Dominion SX R3.1 Technical Bulletin

Release Date: 8 August, 2007

Description

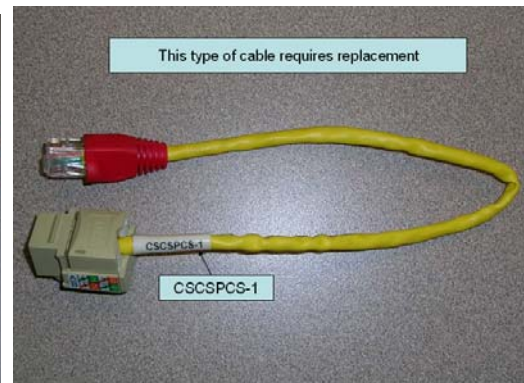
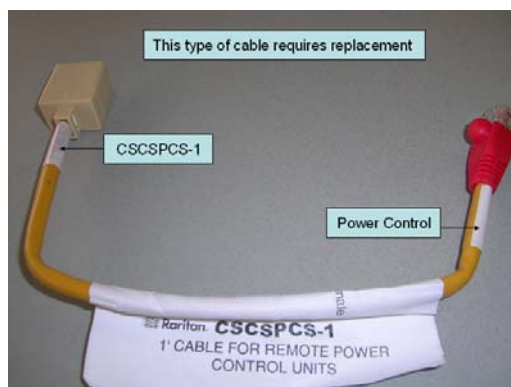
- If the label marked as "CSCSPCS-10" (close to the yellow boot) is located far from the label marked as "POWER CONTROL" (close to the red boot), the cable needs to be replaced.

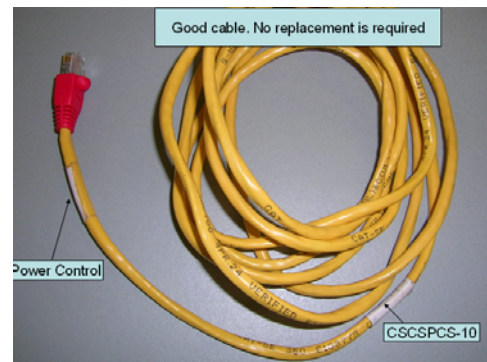
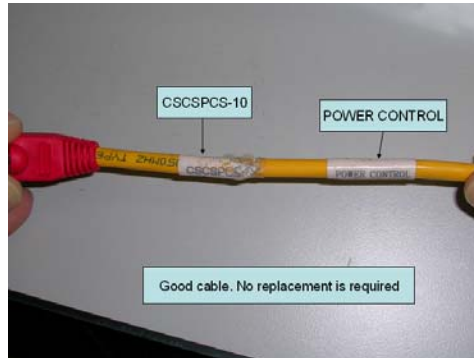
- If the label is marked as "CSCSPCS-1", the cable needs to be replaced.

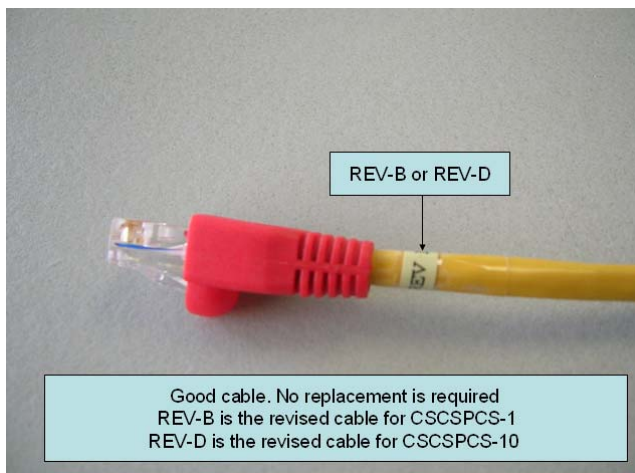
- If the label is marked as “CSCSPCS-10” and it’s placed close to another label marked as “POWER CONTROL” towards the red boot, no replacement is necessary.
